Subject: Arkansas Nuclear One - Units 1 and 2
Docket Nos. 50-313 and 50-368
License Nos. DPR-51 and NPF-6
Additional Information Regarding Technical Specifications Change
Request to Delete Reactor Coolant Pump Flywheel Inspections

Response to Questions Related to "Relaxation of Reactor Coolant Pump Flywheel Inspection Requirements"

Figure 12. Determination of Allowable Flaw Size ($t/R = \infty$) - Waterford-3

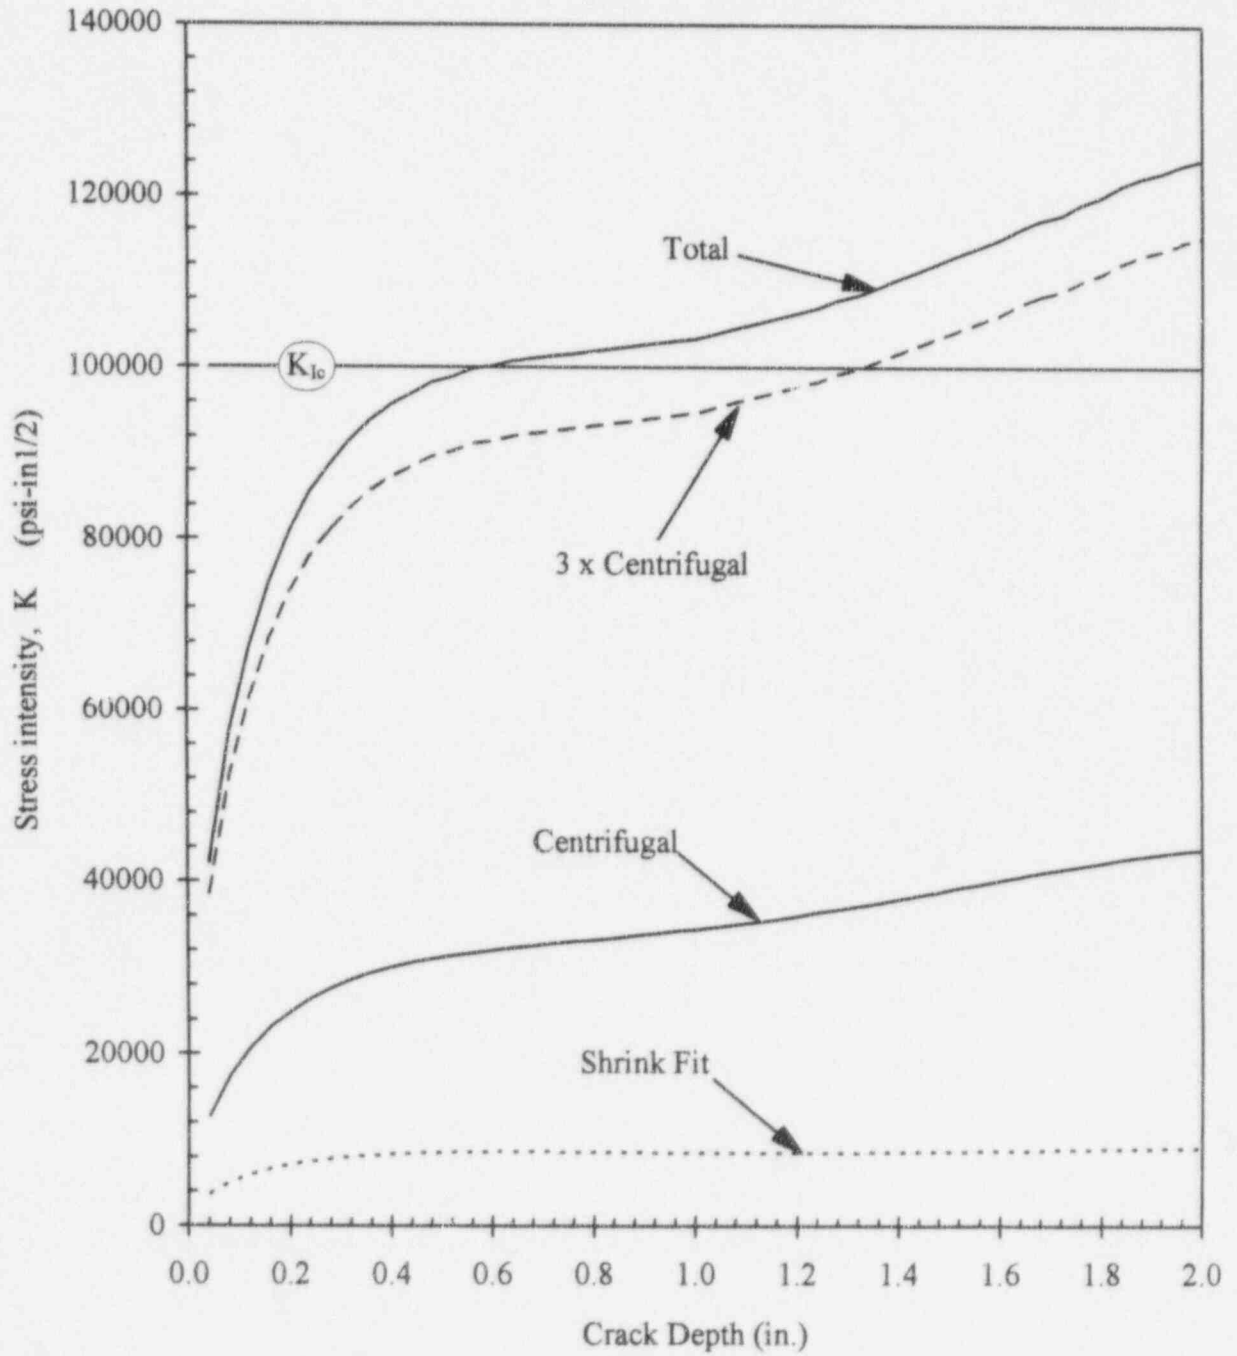
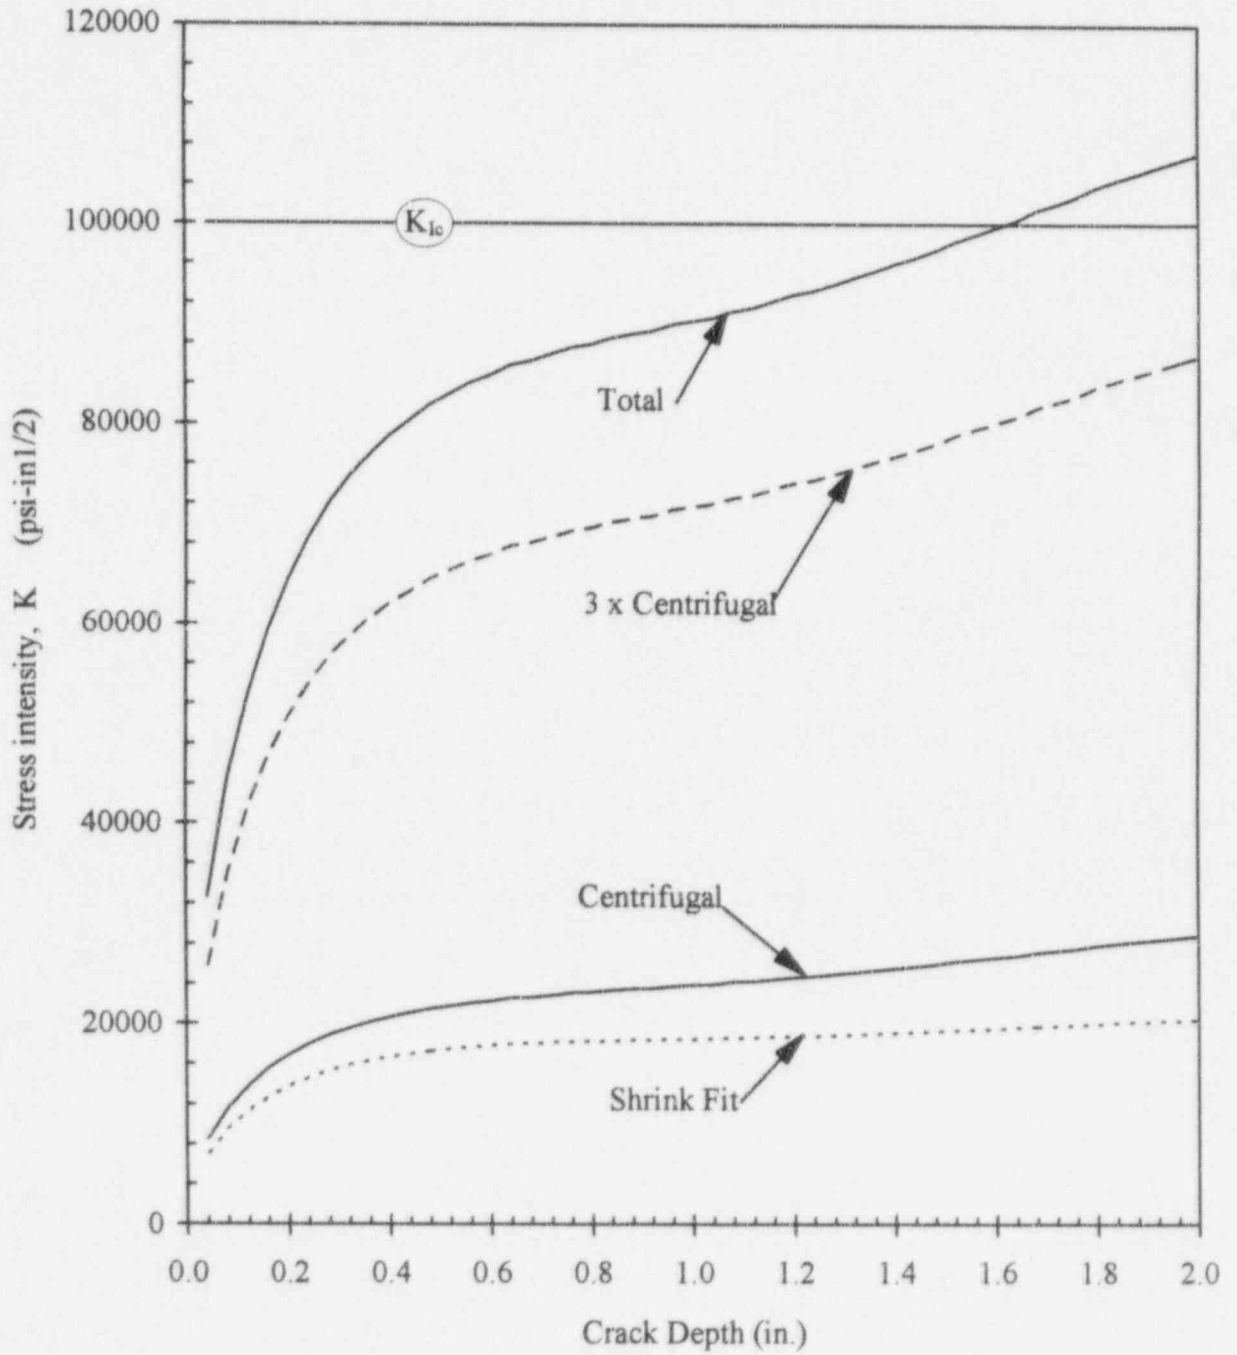
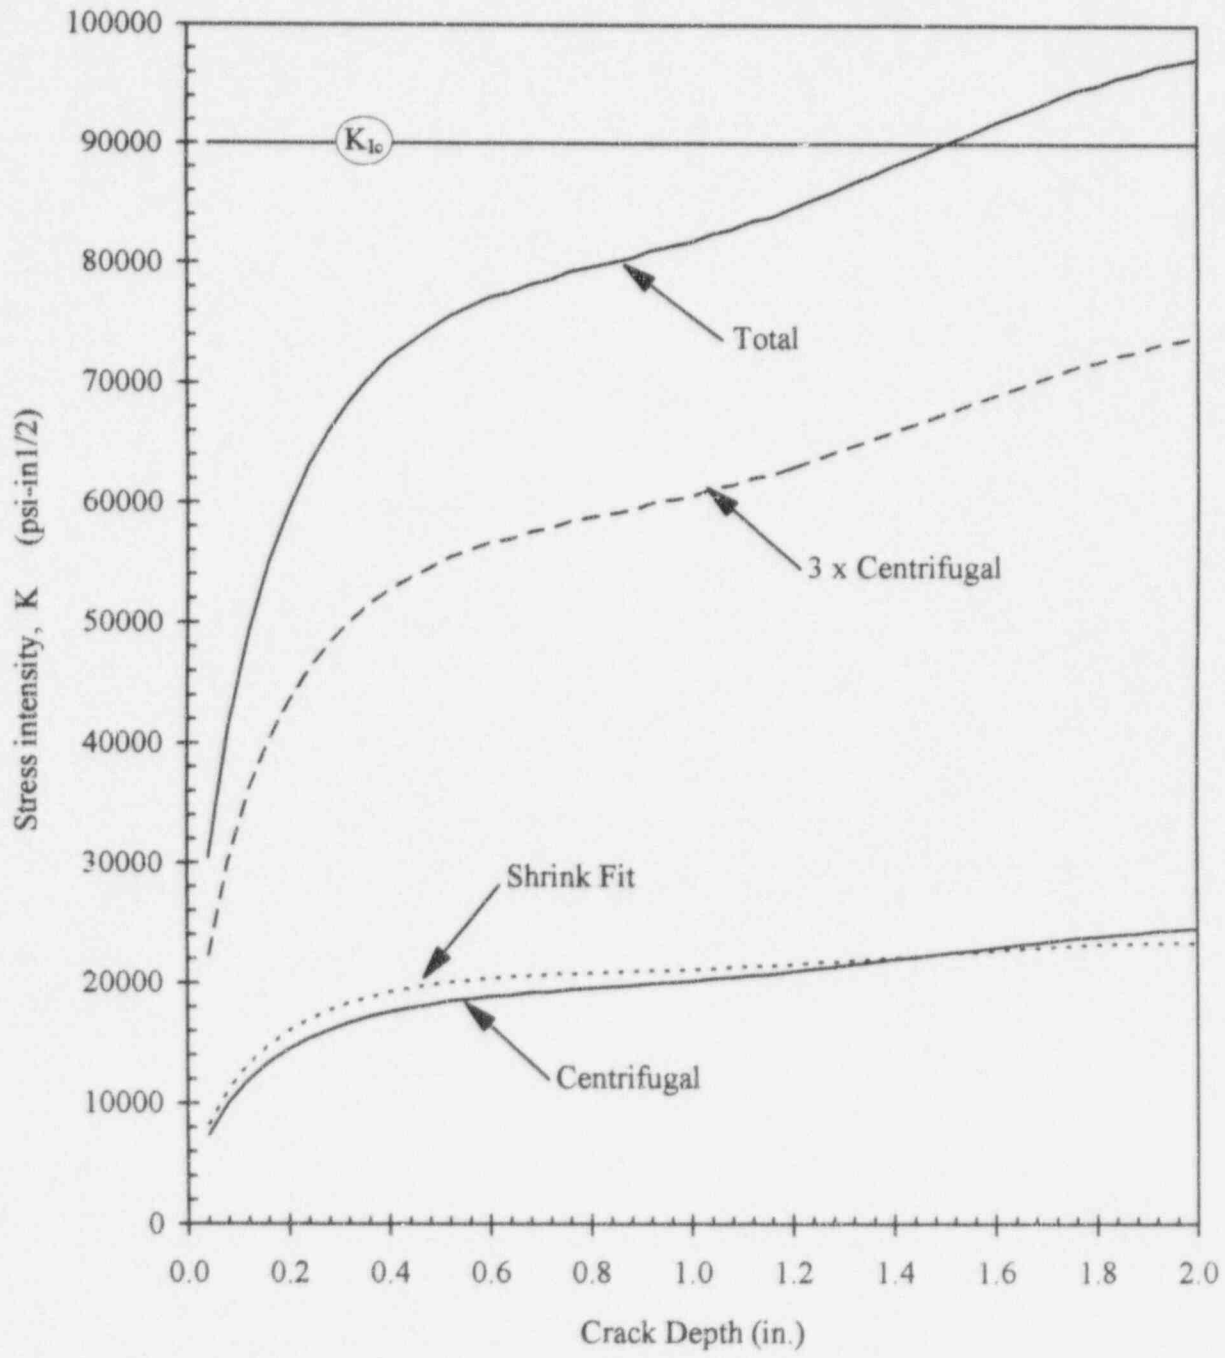
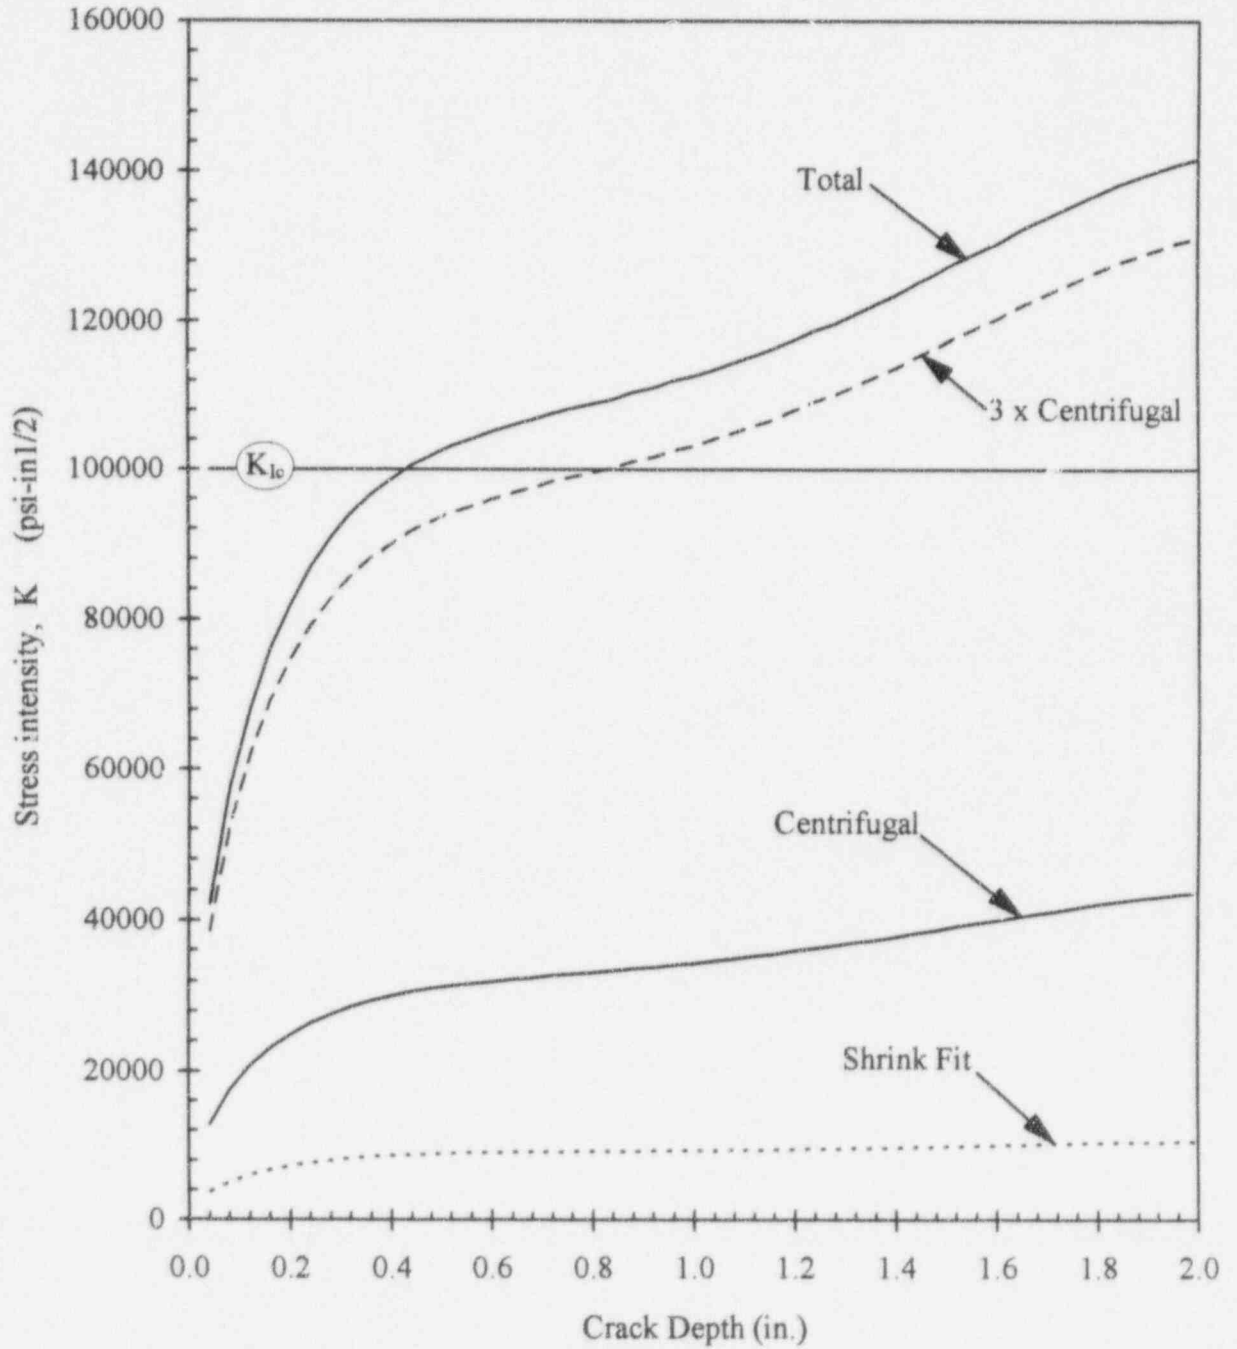
5. **Section 6.3, Allowable Flaw Size Determination, Pg. 6-6:** It was stated that the stress intensity distribution for the centrifugal and the shrink-fit stresses are compared separately with the allowable fracture toughness to determine the allowable flaw sizes. Under normal operating conditions, the staff believes that contributions from both centrifugal and shrink-fit stresses to the applied stress intensity factors are comparable and should be combined. Figures 6-3 through 6-8 indicate that when the combined effect is considered the ASME Code criteria may not be met even for the initial crack size of 0.25 inch. Clarify this. Also, provide a revised copy of Figures 6-3 and 6-14 by adding the stress intensity due to shrink fit at the proper speed to the stress intensity due to centrifugal load.

In the subject report, the centrifugal and the shrink-fit stresses were treated separately to determine the allowable sizes since the maximum stresses for these two loads do not occur at the same time. This approach was considered reasonable since very conservative shrink-fit values were used in the analysis (5.2 mils for the small-bore flywheels and 12.5 mils for the large-bore flywheels). In addition, the shrink-fit stresses are secondary (displacement type) stresses whose contribution to fracture is not as significant as the primary centrifugal stresses. It is expected that because of the very conservative initial shrink-fit values assumed in the analysis, that some amount of shrink-fit will still be present at the normal operating speed of the flywheel.

To determine the residual shrink-fit values at normal operating speed, the finite element analysis performed in support of the subject report was reviewed to determine the relative displacement (initial shrink-fit minus centrifugal displacement) at normal operating speed. This relative displacement was used to calculate the residual shrink-fit stresses at normal operating speed. Stress intensity factors calculated for the centrifugal and residual shrink-fit stresses at normal operating speed are shown in Figures 7 through 15 for all the flywheels that were evaluated in the subject report. For the large-bore flywheels, a model with t/R ratio of 1.2 was used to calculate the applied stress intensity factor and is shown in Figures 7 through 9. For the small-bore flywheels, stress intensity factors were calculated using t/R ratios of 1.2 and infinity as shown in Figures 10 through 15.

To determine the allowable flaw size, a safety factor of 3, consistent with ASME Code Section XI, was applied to the centrifugal stresses since these are primary stresses. A safety factor of 1 was applied to the shrink-fit stresses since these are displacement type stresses which do not contribute to the fracture of the ductile materials. All the flywheels operate in the upper shelf region and are therefore expected to exhibit very ductile behavior. Precedent for the use of a safety factor of 1 for secondary stresses has been established in ASME Code, Section XI, Appendix C for materials that exhibit elastic-plastic fracture behavior. The comparison of the total factored applied stress intensity factors with the fracture toughness for the flywheels are shown in Figures 7 through 15. The allowable flaw sizes resulting from these comparisons are shown in Table 3.

It can be seen that these allowable flaw sizes are greater than the final flaw sizes for the assumed initial flaws of 0.25 inches in the flywheels, even when the conservative shrink-fit stresses are considered in the evaluation and, even if a conservative model with $t/R = 1.2$ is used for the small-bore flywheels. This demonstrates that the conclusions of the subject report are not changed by inclusion of the secondary shrink-fit stresses in the determination of the allowable flaw sizes.
